Sheet: /
File: power_supply.sch

**Title: CommCube Power Supply**

| Size: USLetter | Date: 2021-09-26 | **Rev: 1.02** |

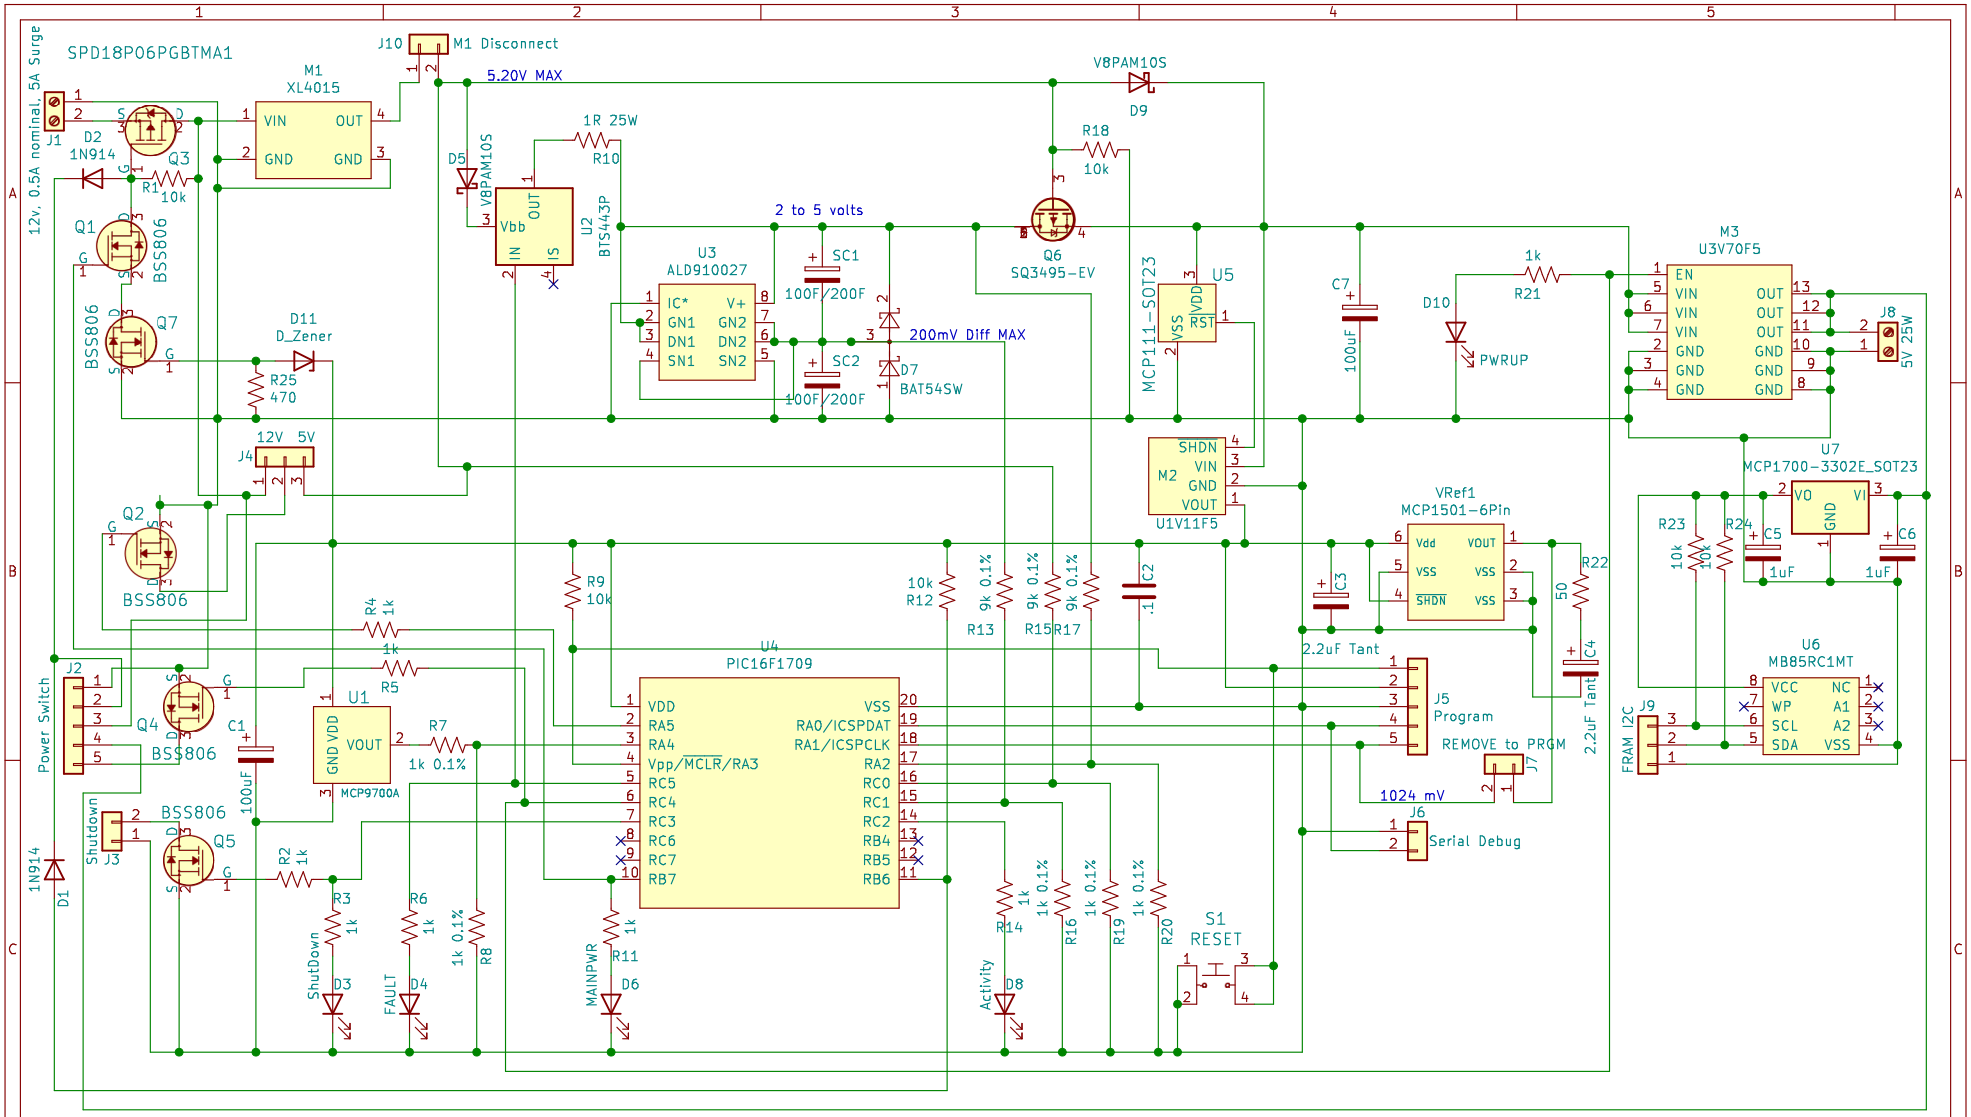
Validated footprints
Added M1 Disconnect J10
Added C7, Q7 and D11 to monitor PIC power. Below 3v3 will not allow splurious signals to bootstrap Q3
